ADDENDUM

ATTACHED TO AND PART OF M.A.C.H. 3 (GAME GV-109)

GAME AS SHIPPED VARIES FROM THE INSTRUCTION MANUAL AS PRINTED

INTERFACE BOARD ASSY. (A2)
PART NO. MA-499

INTERFACE BOARD ASSY. (A2), COMPONENT LOCATION

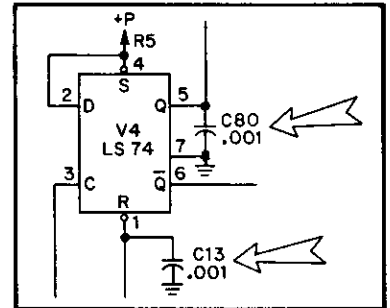
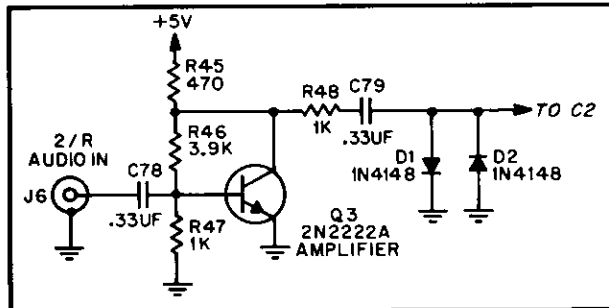
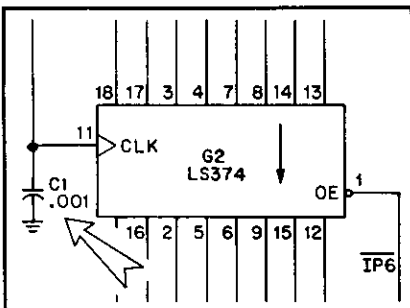
1. Circuit revisions for this assembly have been implemented in this game. The following changes denoted and illustrated below will update pages 38, 39 and 40. Keep this addendum with your instruction manual for future reference.

DELETED:

C32 Capacitor, 820PF, 50V CM-AX, ±80%-20%.....XO-692

ADDED:

C1, C13, C80 Capacitor, .001UF, 50V CM-AX, ±80%-20%.....XO-695
 C78, C79 Capacitor, .33UF, 50V CM-AX.....XO-295
 D1, D2 Diode, 1N4148.....XO-261
 Q3 Transistor, NPN, 2N2222A.....XO-320
 R45 Resistor, 470 OHM, 5%, 1/4W.....XO-35
 R46 Resistor, 3.9K OHM, 5%, 1/4W.....XO-39
 R47, R48 Resistor, 1K OHM, 5%, 1/4W.....XO-5
